Access Compliance Report Public Rights-of-Way (Curb Ramps)

Main Street: WINDSOR_LN Cross Street: NEWPORT_AVE Location: SE

ADA ID: RPAT211027115241 Ramp Type: Type 1 - Perpendicular Diagonal Initial Pass/Fail: Pass Overall Compliance: No Severity Score: 2

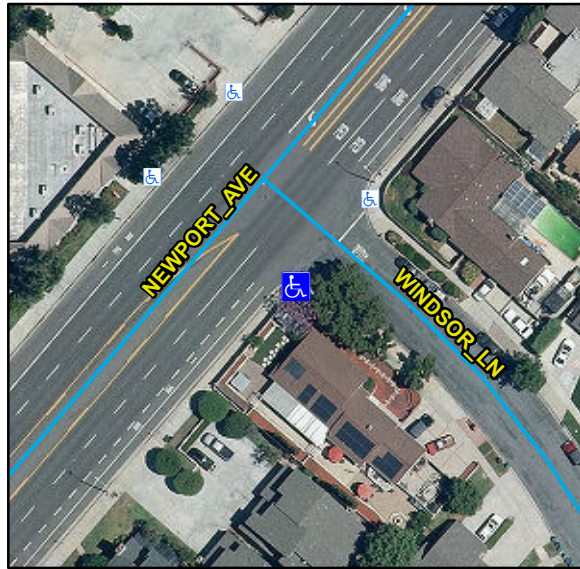
Compliance	Description	Data	Compliance	Description	Data
N/A	Ramp Length (in)	42	N/A	Flare Type LT	
Yes	Ramp Width (in)	48			Sloped
Yes	Ramp Run Slope (%)	6.7	N/A	Flare Slope LT (%)	1.7
No	Ramp Cross Slope (%)	2.4	N/A	Flare Traversable LT	No
N/A	Landing Present	Yes	N/A	Flare Type RT	
N/A	Landing Length (in)	60			Sloped
Yes	Landing Width (in)	48	Yes	Flare Slope RT (%)	8.1
Yes	Landing Run Slope (%)	1.8	N/A	Flare Traversable RT	Yes
Yes	Landing Cross Slope (%)	1.2	Yes	DWS Provided	Yes
N/A	Landing Movement Obstructed?	Yes	Yes	DWS Contrast	Yes
	Landing Movement Type	Curb	Yes	DWS Length (in)	36
N/A	Landing Shared	No	Yes	DWS Full Width	Yes
N/A	Clear Space	Yes	Yes	DWS Offset Left (in)	0
N/A	Clear Space To Crosswalk (in)	48	Yes	DWS Offset Right (in)	N/A
N/A	Marked Crosswalk 1	No	N/A	Marked Crosswalk 2	No
	Crossing 1 Direction	NE		Crossing 2 Direction	NW
	Marked Crosswalk 1 Width (in)	N/A		Marked Crosswalk 2 Width (in)	N/A

N/A	Ramp Inside Crosswalk 1	N/A	Yes	Ramp Inside Crosswalk 2	N/A
	Crossing 1 Slope (%)	3.8		Crossing 2 Slope (%)	9.1
	Crossing 1 Cross Slope (%)	4		Crossing 2 Cross Slope (%)	1.5
Yes	Gutter Ponding	No	No	Curb Slope	7.1
Yes	Gutter Lip Height (in)	0		Road Run Slope (%)	2.3
Yes	Gutter Run Slope (%)	2.8		Road Cross Slope (%)	6.9
Yes	Gutter Cross Slope (%)	0.8			
Yes	Overall Surface Condition: Acceptable		Yes	Perp Joint Present	Yes
	Cross Gutter Present?	No		Spandrel Present?	No
	Replace Cross Gutter?	N/A		Replace Spandrel?	N/A

Remove & Replace Curb Ramp With Two New Directional Ramps or Equivalent.

R304.2.2, R304.5.3, STD 1115
